Title 14—Aeronautics and Space

[Docket No. 76-EA-100; Amdt. 39-2891]

Piper Aircraft

SUMMARY: This rule requires that holes be drilled in the gas cap of certain Piper Aircraft to allow venting and preclude fuel starvation in certain PA-11, PA-12, PA-14, PA-18, PA-20 and PA-22 airplanes.

VIEW OF FUEL TANK CAP - P/N 15296-02

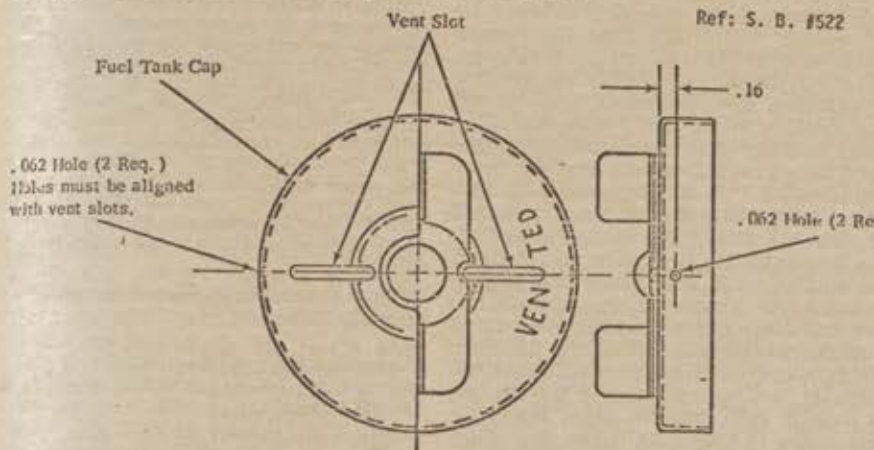
In order to prevent fuel starvation due to obstructed venting around the fuel tank filler cap, accomplished the following:

a. On those aircraft incorporating P/N 15296-02 fuel filler caps which were made available in June 1976, remove each cap from

the wing tanks and alter the caps by drilling two .062" diameter holes 180° apart on the outer edge surface .16" down from the top of the cap. Holes must be aligned with vent slots as shown. Accomplish this alteration on all P/N 15296-02 filler caps or replace these caps with original vented caps and gaskets as listed in the appropriate Piper parts catalog.

CROSS SECTION OF FUEL TANK INLET AND RUBBER SEAL

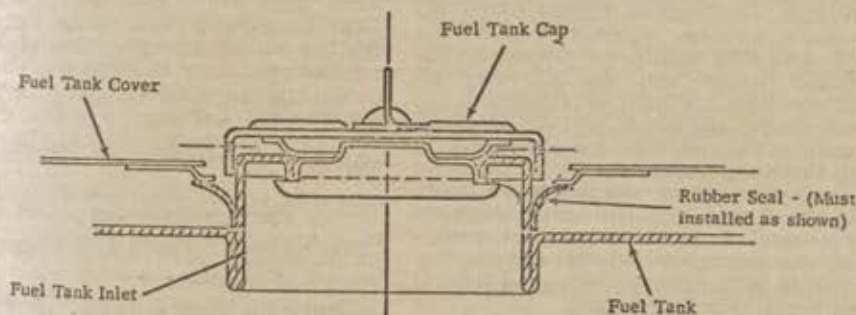
b. Inspect the rubber seal around the fuel tank inlet filler neck to determine if seal was installed inverted or is properly installed as shown. If seal is not installed correctly, remove the fuel tank cover from wing, reposition the seal as shown and reinstall fuel tank cover.
